SERVICE BULLETIN

Classification: EM01-001	Reference: NTB01-034	Date: May 11, 2001
-----------------------------	-------------------------	-----------------------

2000-2001 SENTRA; EXHAUST MANIFOLD HEAT SHIELD RATTLE

APPLIED VEHICLE:	2000-2001 Sentra (B15)
APPLIED VINS:	Vehicles built before 3N1BB51DX1L121790
APPLIED DATES:	Vehicles built before January 23, 2001
APPLIED ENGINE #S:	SR20DE engines only, built before engine # 375737

Figure 1

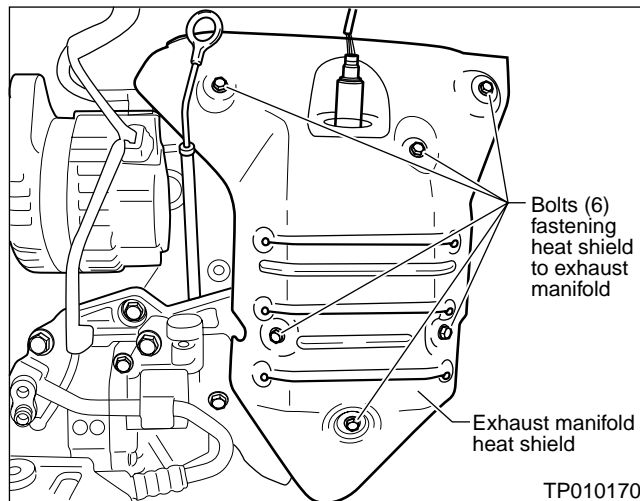
1. With the engine running, find and identify the source of the rattle or buzzing noise.
2. If the noise is coming from the heat shield, check to see if bolts that fasten the heat shield to the exhaust manifold are loose or missing (see Figure 1 below). Remove all or remaining bolts.

Figure 2

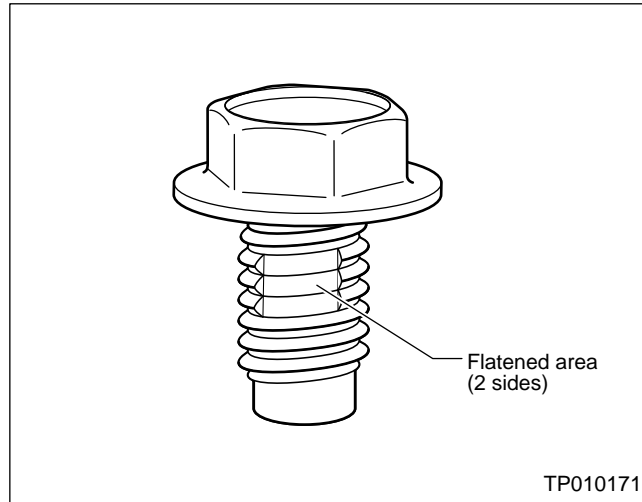
3. Install replacement bolts (6 locations). The replacement bolt has partially flattened threads for increased resistance to loosening. See Figure 2 below to identify replacement bolts.

CAUTION: Do not install the replacement bolt into aluminum parts such as intake manifolds or cylinder heads. Due to the flattened thread design of the replacement bolt, it may damage the threads of tapped holes in aluminum parts.

4. Tighten replacement bolts (6 locations) to 5.1-6.4 N-m (0.52-0.66 kg-m, 46-57 in-lbs.).
5. Test-drive the vehicle to check if the rattle or buzzing noise has been eliminated.
